SEQUOYAH NUCLEAR PLANT
PROPOSED TECHNICAL SPECIFICATIONS

TVA-SQN-TS-36

CHANGE NO. 1

DIESEL GENERATOR BATTERY FLOAT VOLTAGE

SEQUOYAH NUCLEAR PLANT
 DEGRADED AND LOSS OF VOLTAGE
 RELAYING SCHEME

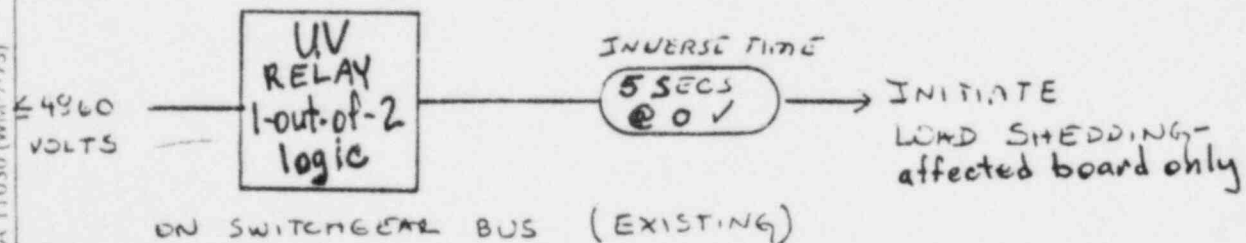
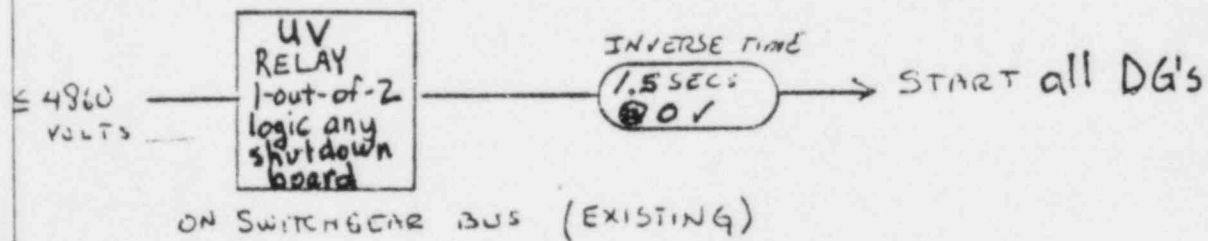
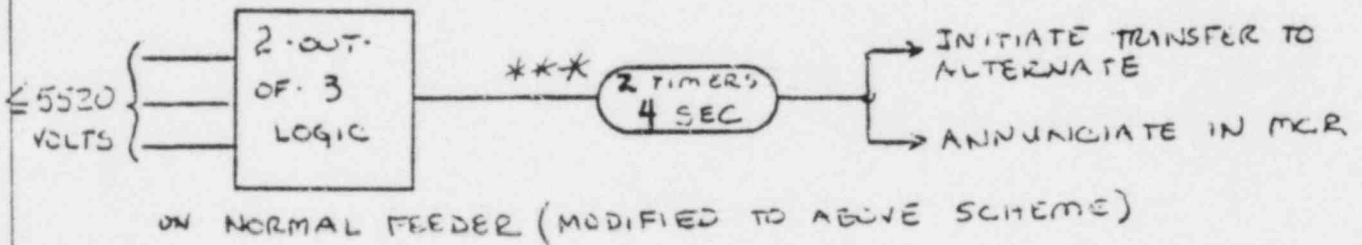
3.2 Modification. TVA will (1) replace the existing loss of voltage relays, on normal feeder breaker only, with three instantaneous solid-state relays (ITE-type 27H) arranged in a two-out-of-three coincidence logic (see Figure A-II). The logic will energize two timers, either of which will initiate transfer to the alternate, if the alternate supply voltage is greater than 95 percent of nominal by tripping the bus normal supply breaker. The relays will have a nominal setpoint of 5520 volts \pm 1 percent (80% of nominal) with a relay/timer combined time delay of 4 seconds + 5 percent. The diesel generator starting and load shedding circuitry described in 3.1 -2,-3 will not be modified. (2) To protect the Class 1E buses from a sustained degraded undervoltage, each of the two 6.9kV Class 1E buses per unit will be provided with a set of three instantaneous solid-state undervoltage relays (ITE-type 27/59H). These relays will have a nominal setpoint of 6560V \pm 1/2 percent (95% of nominal). The relays will be arranged in a two-out-of-three coincidence logic

to initiate three time delay sequences (see Figure A-I). The first sequence of 30 seconds will ride through normal system voltage transients (motor starts - both safety and nonsafety related) before annunciating the undervoltage in the main control room. The second sequence is short enough to allow safety-related equipment to be powered within the time required by the safety analysis. At the end of 10 seconds if an SIS has been initiated, or is subsequently initiated, the shutdown board degraded voltage relays will initiate load shedding and subsequently transfer the shutdown board to its diesel generator. The return of bus voltage initiates load sequencing of safety-related equipment. The third time delay is long enough to allow operator action but not result in damage to connected safety-related equipment. At the end of five minutes, the shutdown board will initiate load shedding and subsequently transfer the shutdown board to its diesel generator if degraded voltage has not been corrected. The error associated with these relay/timers is ± 0.5 percent.

FIGURE B

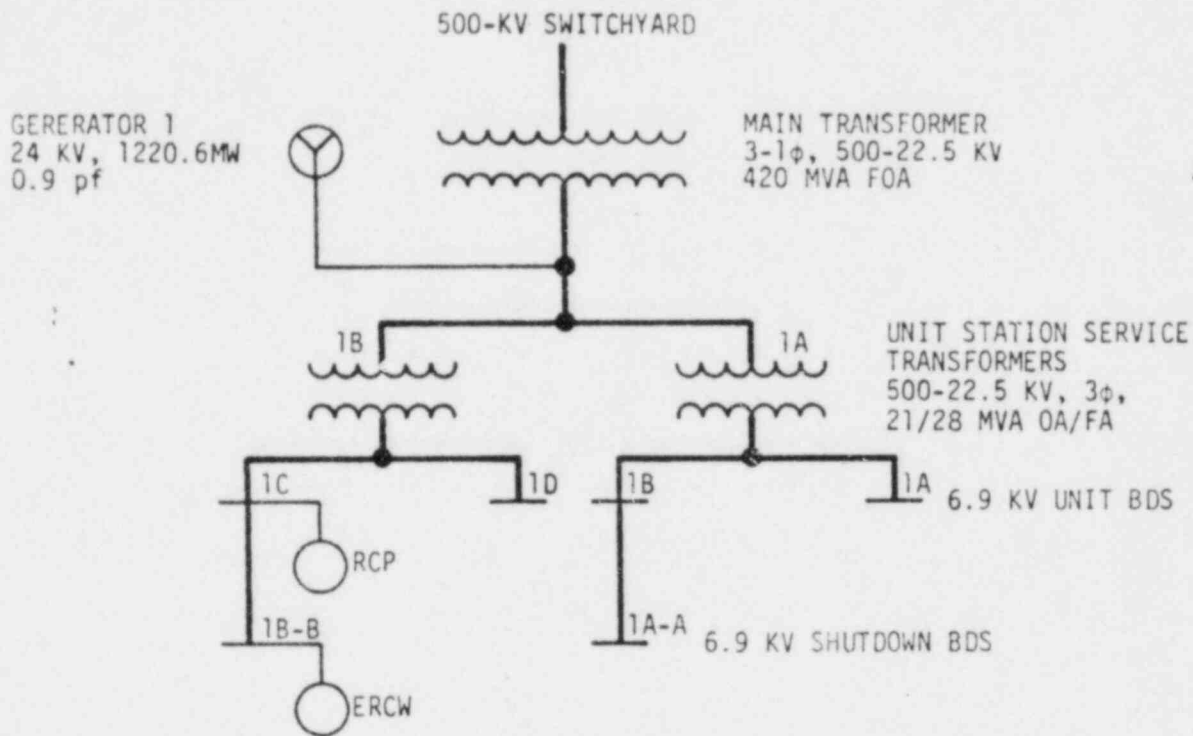
For normal operation of units 1 and 2, the main generator is used to supply power to the plant auxiliary power system through the unit station service transformers. With the main generator at its minimum voltage of 22.8 kV, starting the largest motor on the 6.9-kV unit and shutdown board will not cause spurious tripping of the normal (see Figure B).

FIGURE C

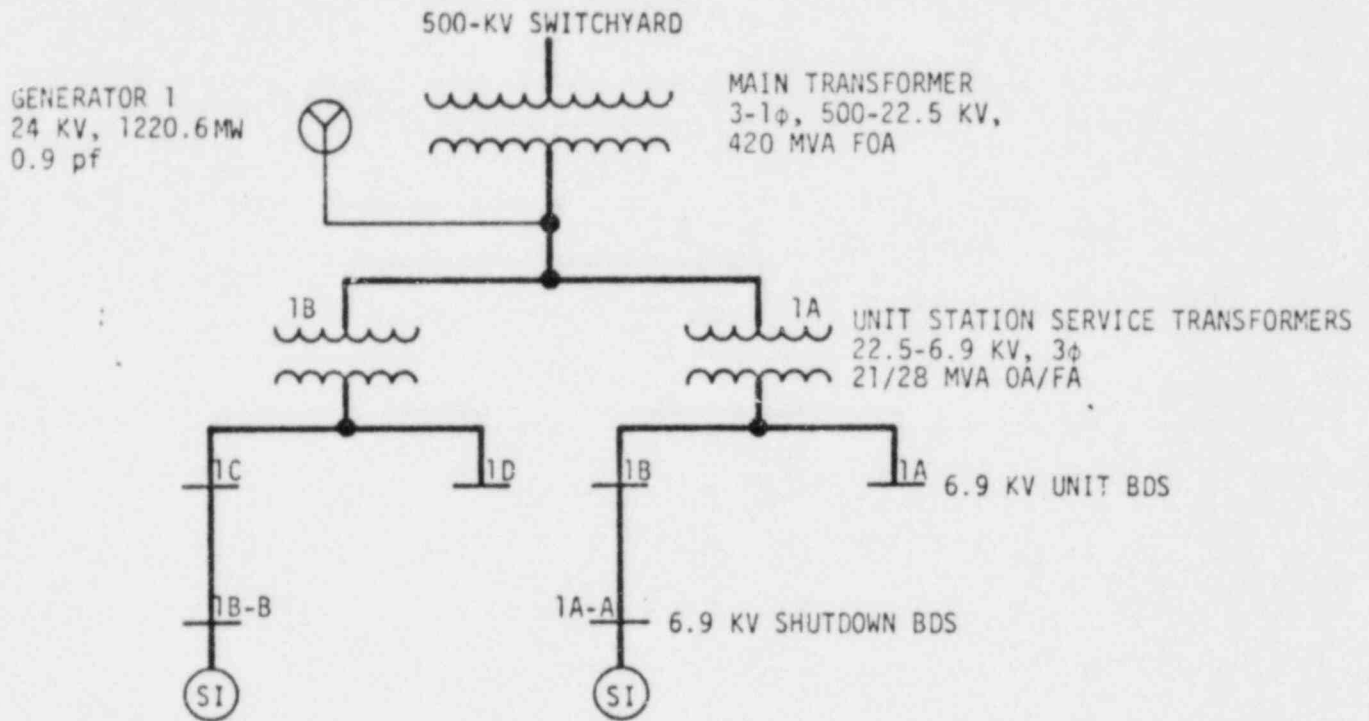
If a safety injection (SI) should occur during normal operation of the unit, the reactor would be tripped and the turbine stop valves closed. If an electrical fault in the generator or switchyard is not present, the generator is not tripped, via the main transformer high-side breaker, for 30 seconds. During this time, approximately 4000 horsepower of SI motors are simultaneously started. The 6.9-kV shutdown board voltage will dip to approximately 6200 volts but will recover to 6640 volts after approximately four seconds, with the main generator voltage at its minimum of 22.8 kV (see Figure C).

FIGURE D

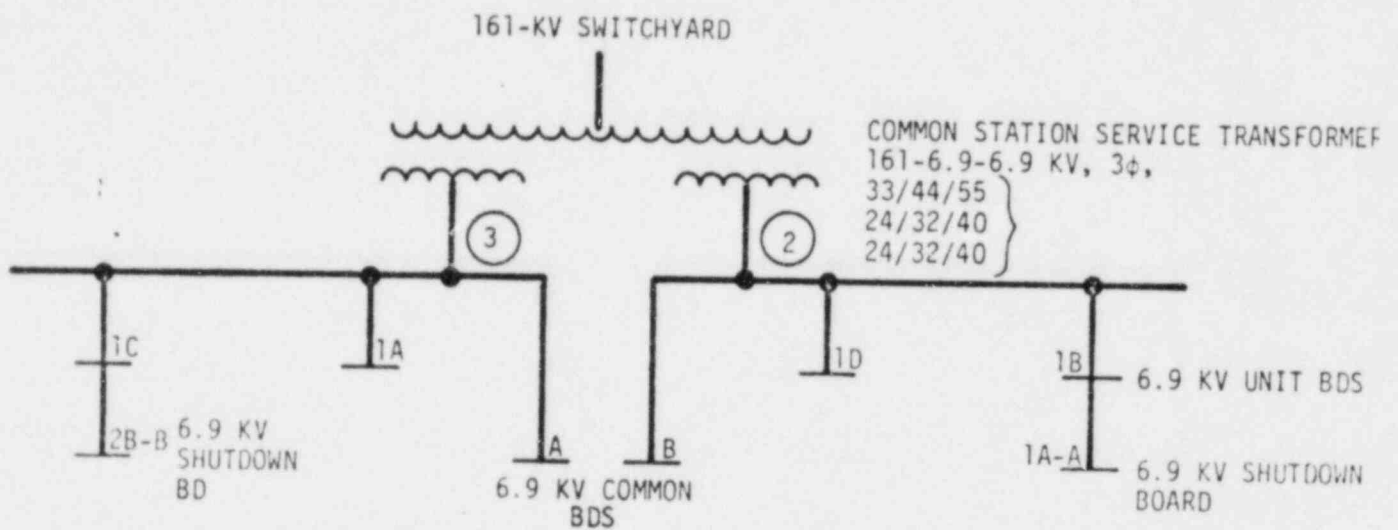
For the same condition, but with an electrical fault of the switchyard or main generator, the 6.9-kV unit boards are transferred (approximately six cycles) to the preferred offsite supply. With one of the two CSST's out of service, the starting of the SI actuated loads will cause the 6.9-kV shutdown boards to dip to approximately 6370 volts for approximately four seconds recovering to approximately 7000 volts, with the 161-kV grid at 162 kV (see Figure D).

FIGURE E

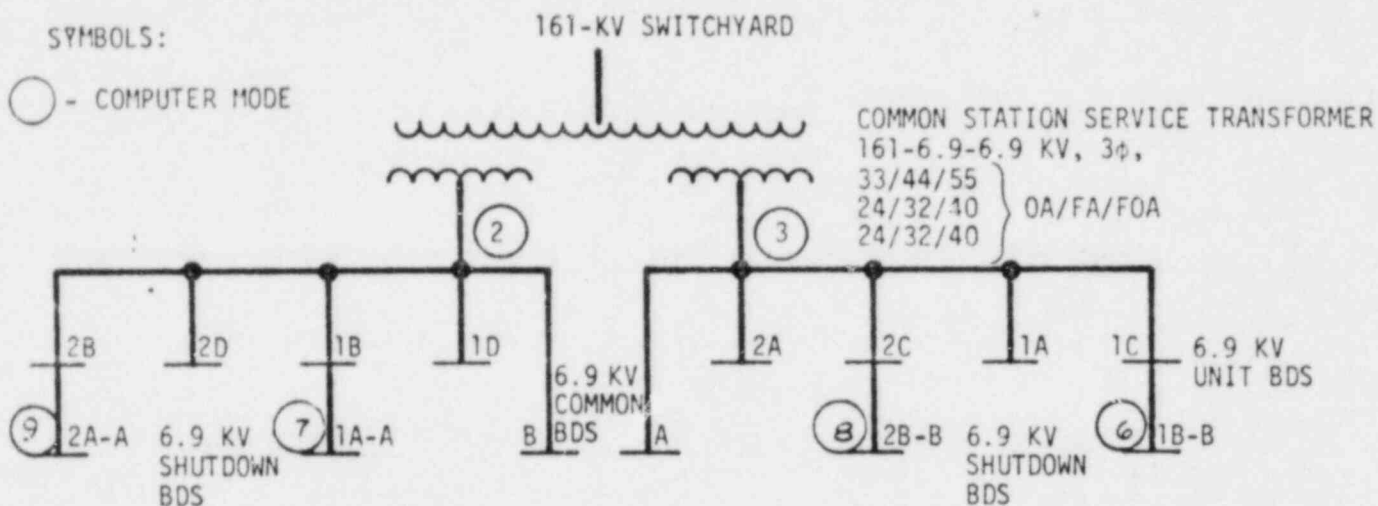
For the case of a two-unit full-load rejection, with one CSST out of service and the 161-kV grid at 162 kV, the steady-state 6.9-kV shutdown board voltages range from 6585 to 6618 volts, which is adequate for starting the required medium- and low-voltage motors (see Figure E).
